Consultation with the Lead Local Flood Authority on the Proposed Development at Land South-East of Rugby Road, Clifton-upon-Dunsmore

Thank you for your comments regarding the outline planning application for a proposed residential development and associated works at Land South-East of Rugby Road, Clifton-upon-Dunsmore (planning application reference: R25/0565; consultation reference: WCC003605/FRM/SL/001).

Richborough
Land East of Rugby Road
Clifton-upon-Dunsmore, Rugby
Culvert Capacity Assessment Technical Note

Figure 1.1: Unnamed Ordinary Watercourse and Culvert Network

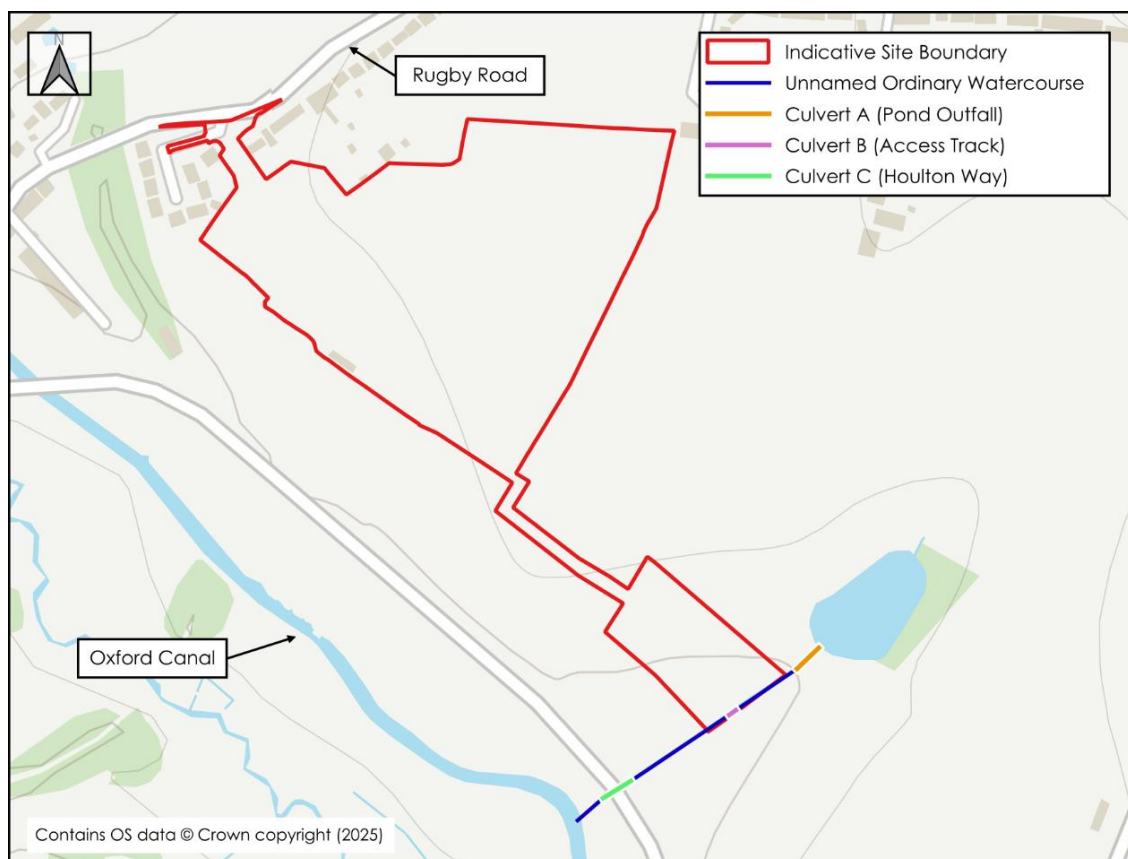
Firstly, further information related to the ordinary watercourse and proposed point of outfall was requested. We have undertaken an assessment of the existing and proposed flows into the existing culverts associated with the unnamed ordinary watercourse (UOW), with consideration of climate change, and of the capacity of these culverts. This assessment is detailed in the appended Culvert Capacity Assessment Technical Note (reference: 244849-BWB-ZZ-XX-T-W-0003_CCA, dated November 2025) and can be seen in **Appendix 1**. It was concluded that the culverts downstream of the proposed outfall location have sufficient capacity to accommodate the post-development flow rates.

- 1.4 This report is intended to provide a technical summary for the assessment of the capacity of culverts along an Unnamed Ordinary Watercourse (UOW), which the surface water drainage strategy for the proposed development is proposed to discharge to. The location of the UOW and associated culverts is shown in **Figure 1.1**.

Figure 3.1: Catchment Areas

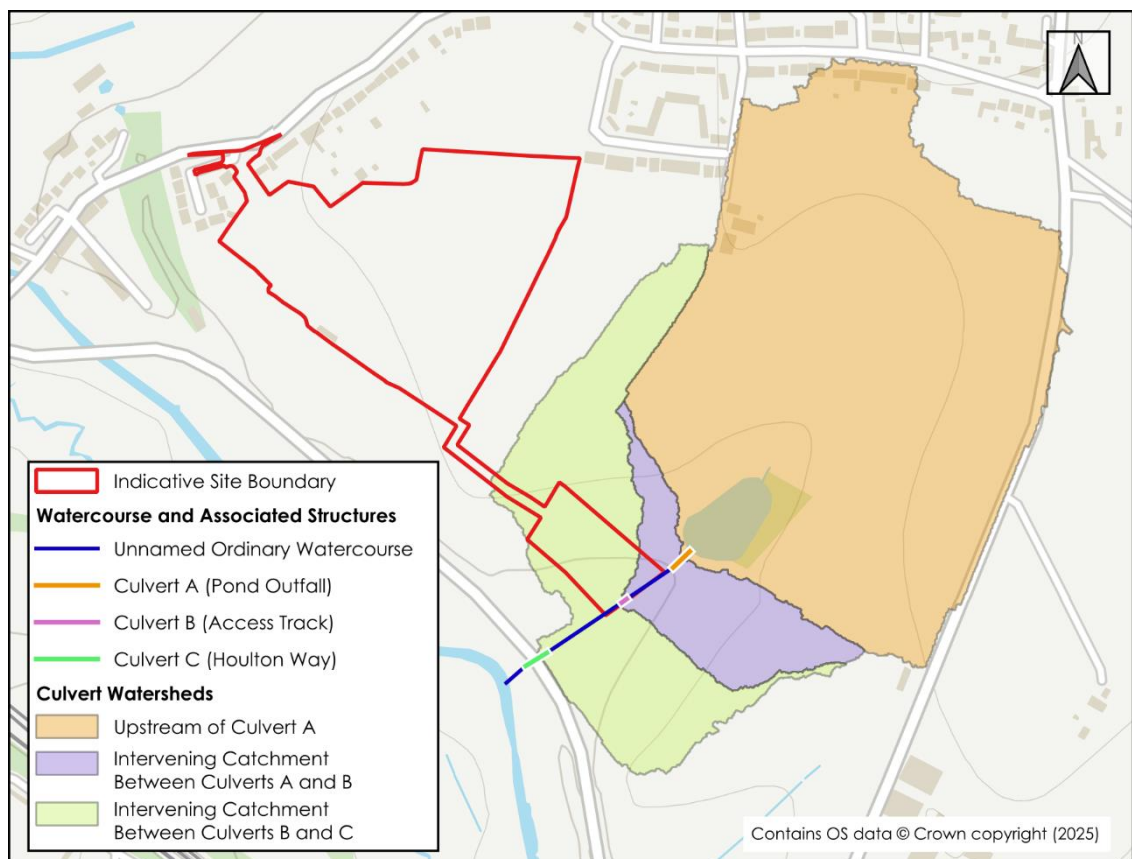
- 3.5 However, it is noted that the flows from the upper catchment are limited by Culvert A, which effectively throttles flows and limits the flow rate to the downstream culverts. As such, the existing flows through these culverts are not considered to be equivalent to greenfield rate. Therefore, the flows from the intervening catchments between the culverts, illustrated in **Figure 3.1**, were also estimated for use in the assessment.

Drawing Title
Existing Site Plan Sheet 1 of 2

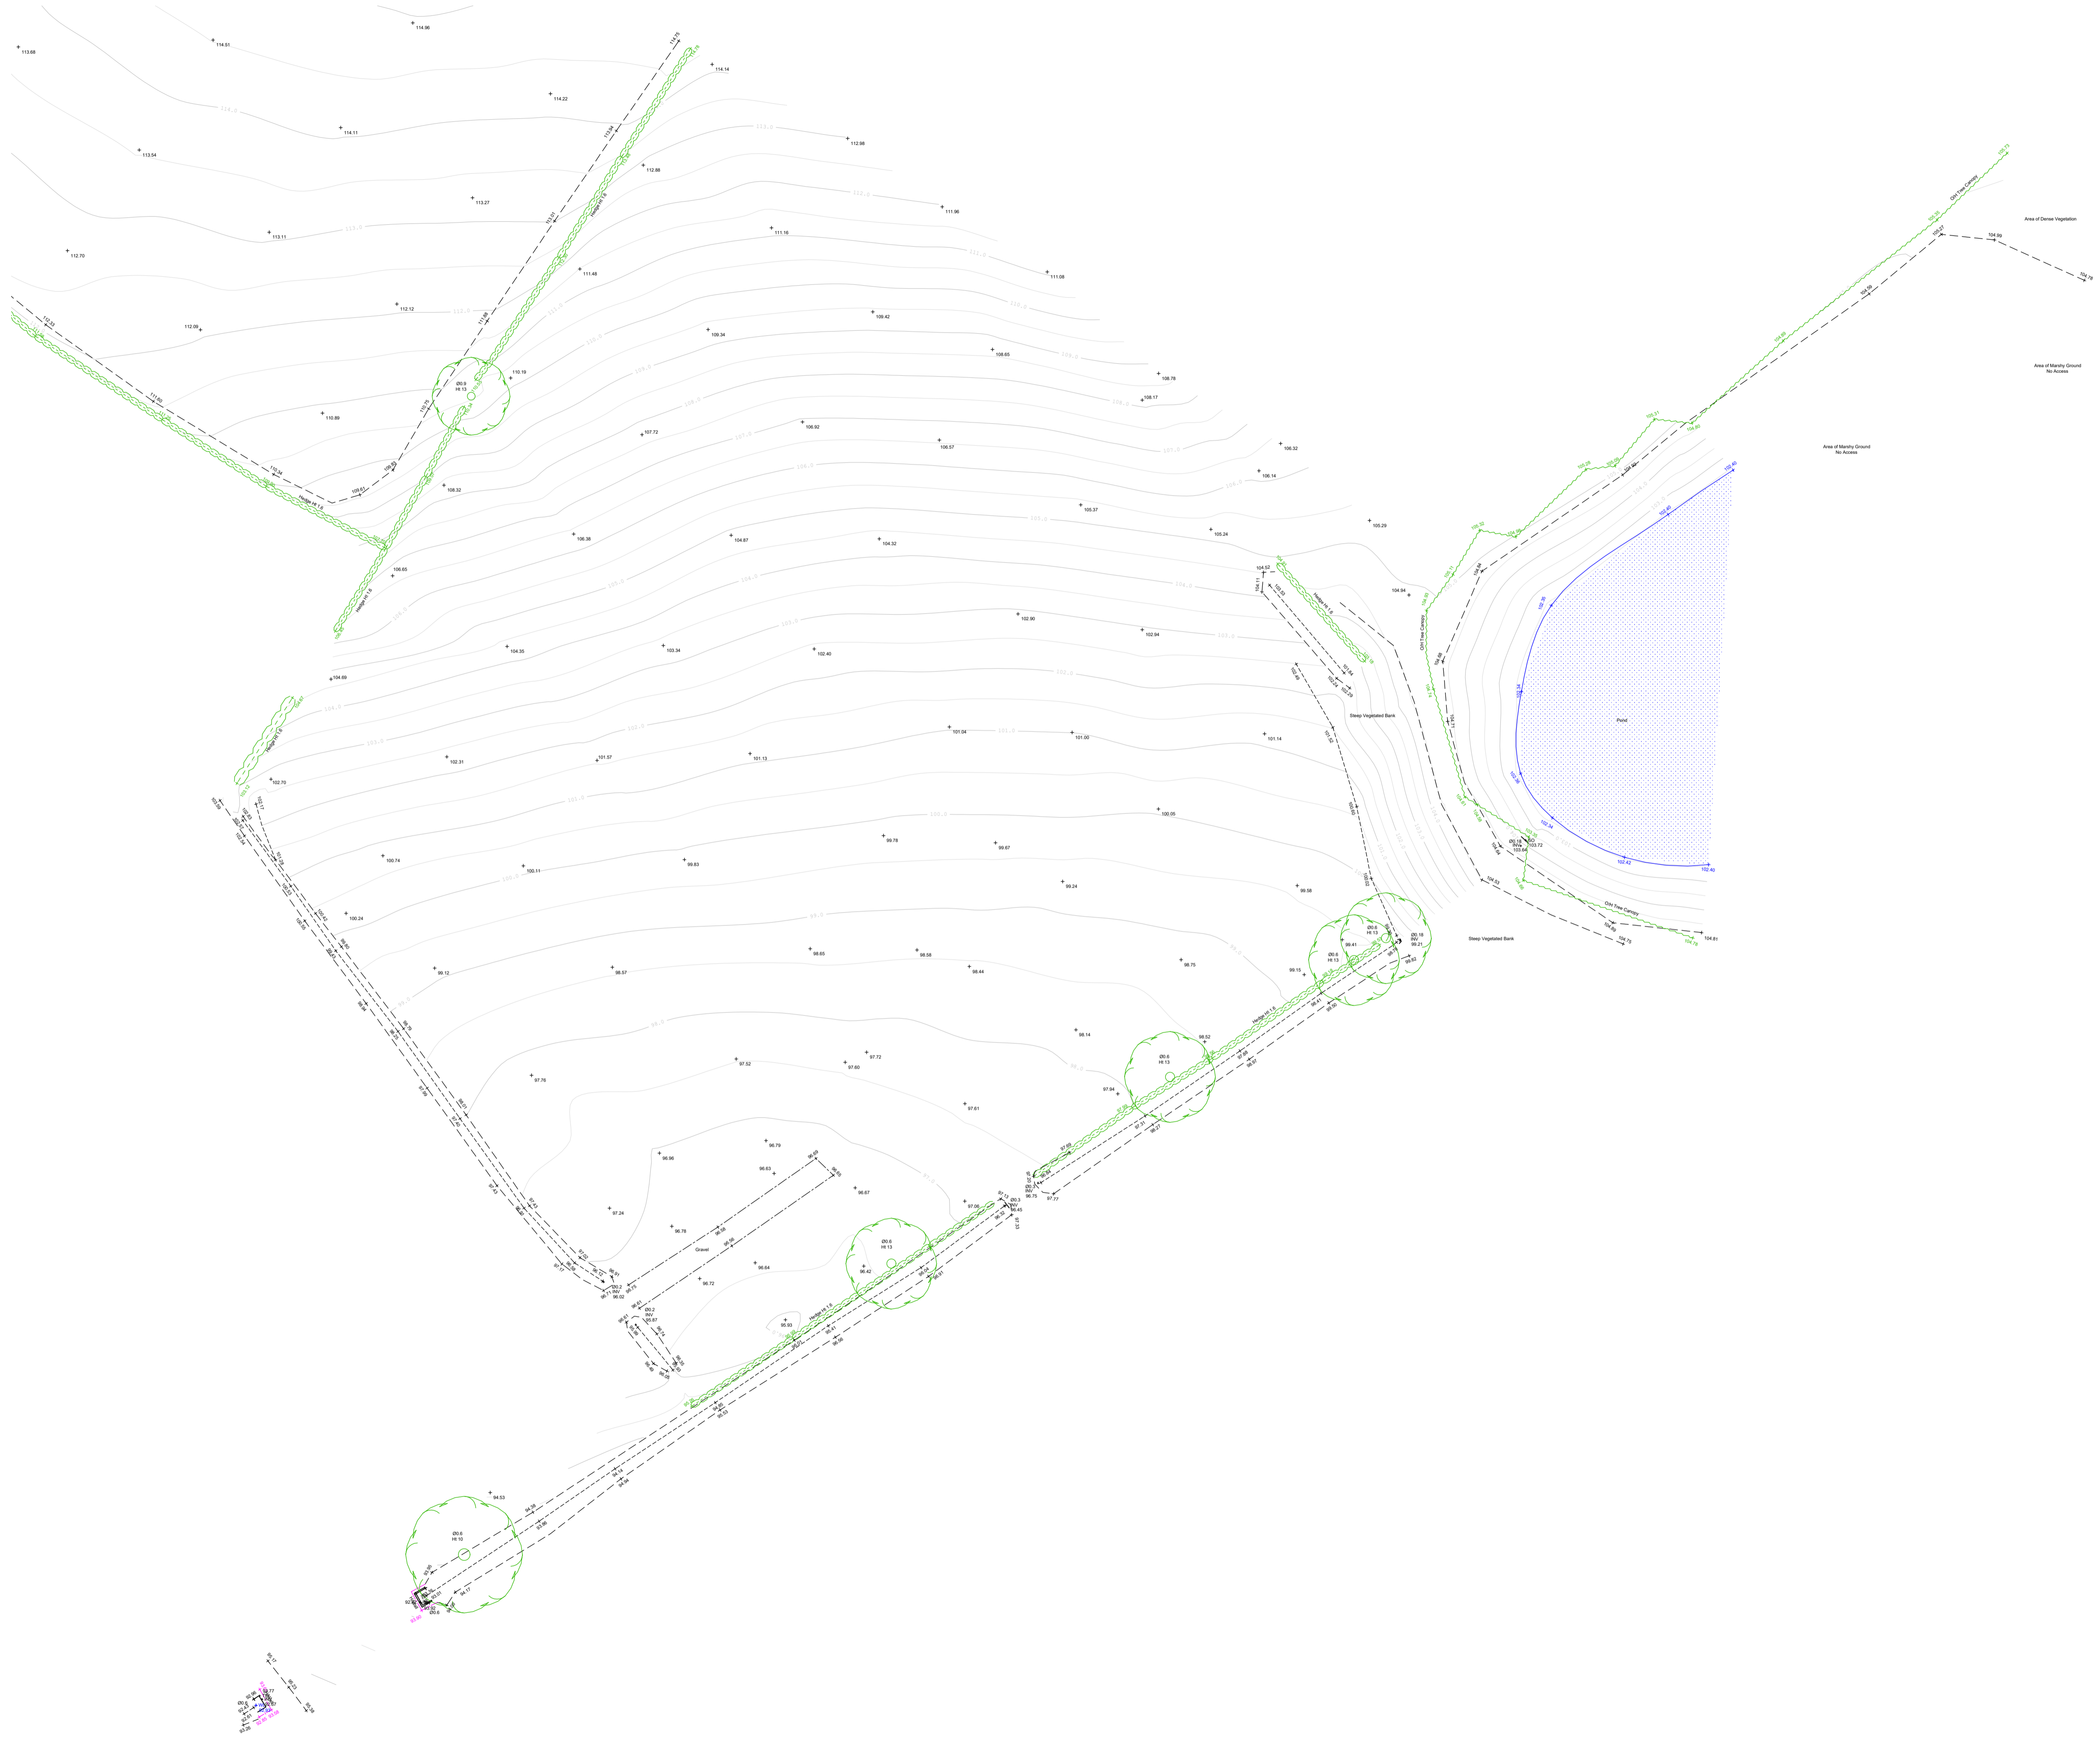
The second point raised was that the topographical survey provided as part of the submission did not cover the entirety of the site boundary. Further survey was undertaken by BWB Consulting in October 2025 to capture the proposed route of the surface water drainage outfall as well as the UOW and associated culverts. The topographical survey is appended to the Culvert Capacity Assessment Technical Note within **Appendix 1**.
